ALERT SERVICE BULLETIN

NO. 407-00-38
DATE 12-08-00
PAGE 1 of 7

MODEL AFFECTED: 407

SUBJECT: FUEL VENT LINE, REPLACEMENT OF

Figure 1. Baggage Compartment Closeout

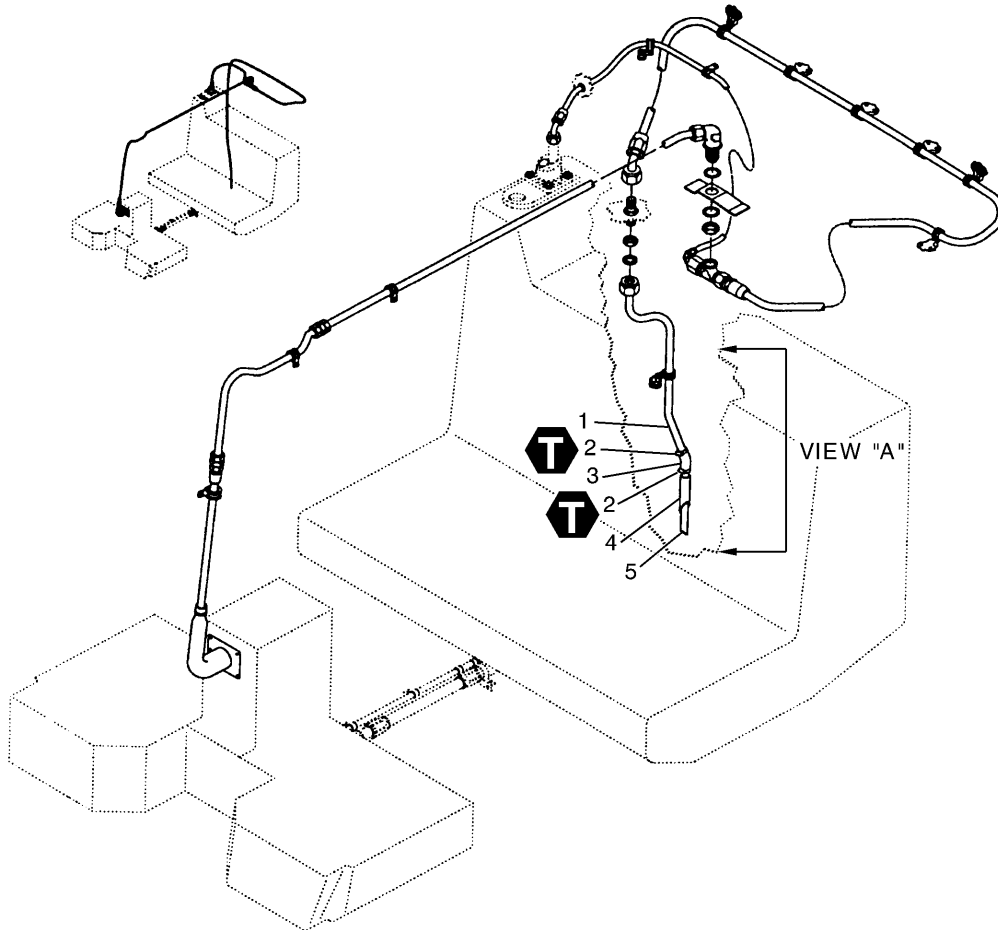
2. If installed, remove the Auxiliary Fuel Tank Kit. Refer to BHT-407-MMS-6, paragraph 28-7.
3. Remove the interior baggage compartment bulkhead closeout panel (1). Refer to Figure 1.

9. Use the hardware removed in step 3 to install the interior baggage compartment bulkhead closeout panel (1).
10. Make an entry in the aircraft technical records to show that this Alert Service Bulletin is completed.

Figure 2. Fuel Vent System (Sheet 1 of 2)

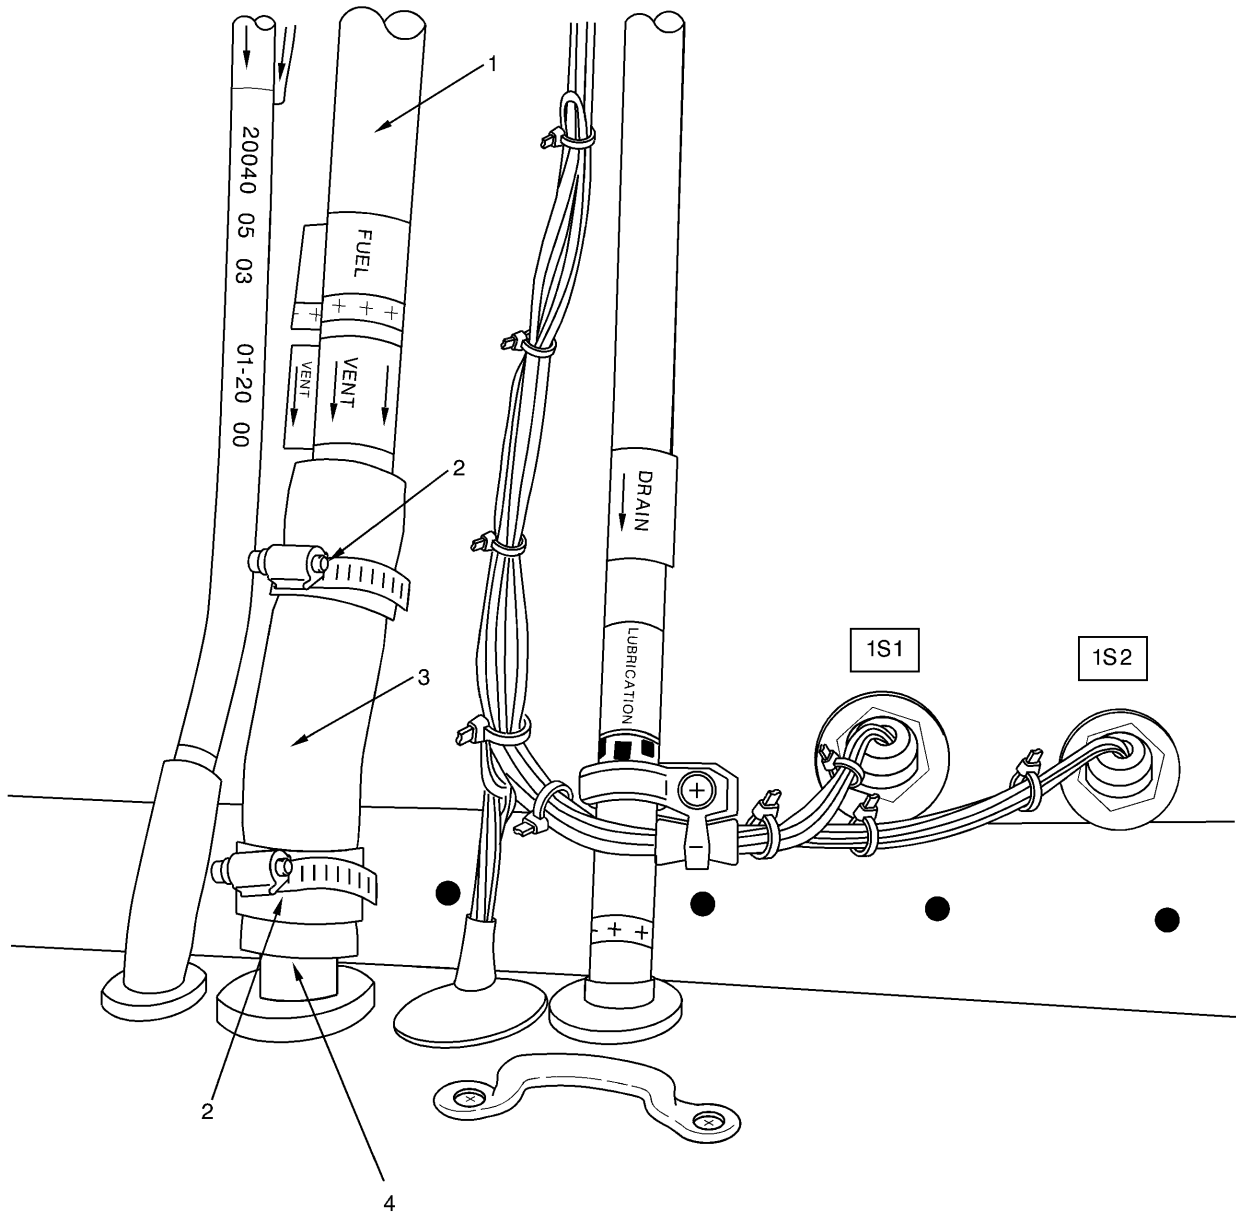
Bell Helicopter has learned of several instances where the flexible fuel vent line 110-107-32A-035 has cracked and is allowing fuel vapors into the baggage compartment. Because of this, Bell Helicopter requires the replacement of the existing flexible fuel vent line.

This bulletin gives the instructions to replace the flexible fuel vent line 110-107-32A-035 in the aft baggage compartment area. The new vent line BEL103206001404 is made of a different, more durable material. It is a direct spares replacement for the existing fuel vent line.

4. Remove the two hose clamps (2) that hold the flexible fuel vent hose (3). Refer to Figure 2, sheets 1 and 2.
5. Remove the flexible fuel vent hose (3).

6. Install the new flexible fuel vent hose (3).
7. Install the two hose clamps (2), removed in step 4, to secure the new flexible fuel vent hose to the fuel vent hose (5) and fuel vent tube (1). Torque the hose clamps (2) to 15-25 in-lbs.

- 1. Tube (407-062-004-101)
- 2. Hose clamp (AN737TW38)
- 3. Rubber tube remove (110-107-32A-035)
install (BEL103206001404)
- 4. Hose (206-062-663-001)
- 5. Composite tube (407-062-013-101)
